Harrogate Cycle Action Response to NYC Highways Consultation on Wetherby Road/Railway Road Scheme

Figure 6-4: User hierarchy for streets

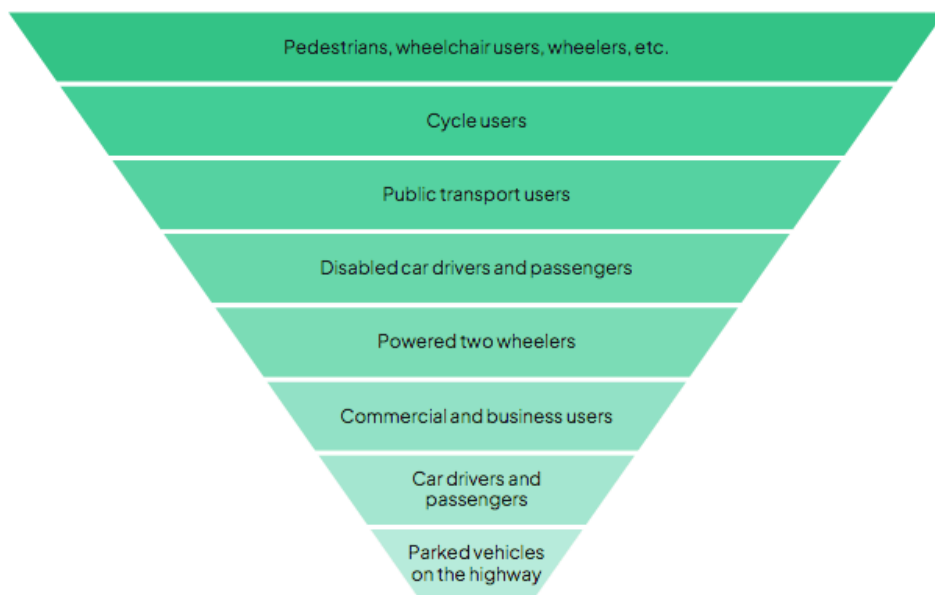
The region's draft LTP has cycle users second from top in the hierarchy of road users, and car drivers and passengers second from bottom.

In this scheme, NYC Highways is using its own funds to increase motor vehicle throughput – in practice, its top priority. It has obtained outside funding for pedestrian crossings – arguably therefore second priority. It is proposing to do nothing at all for cycle users – who are thus not a priority at all. This is wrong.

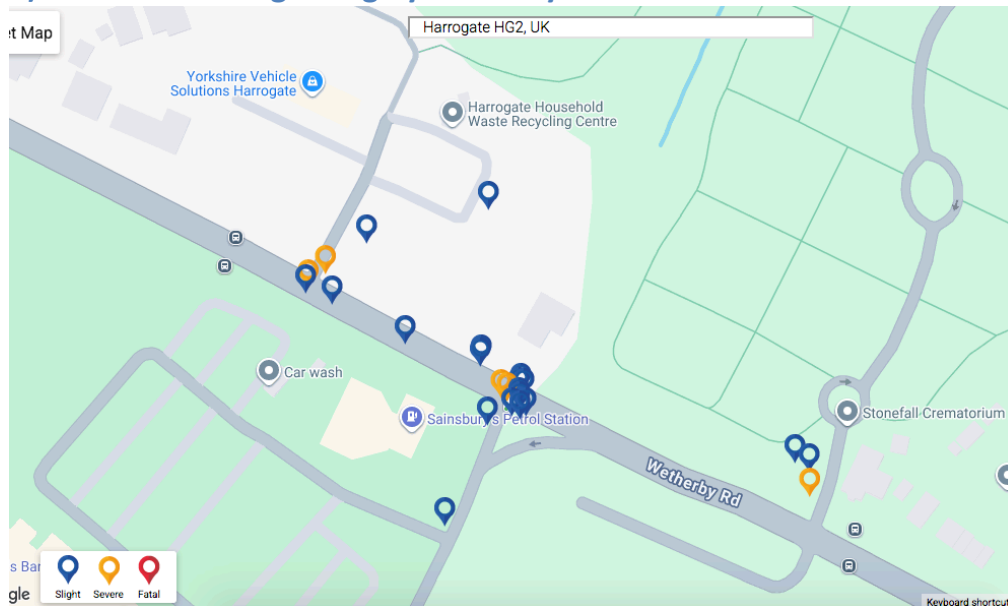
It is clear from the Think! map above that there has been a significant number of collisions at this junction.
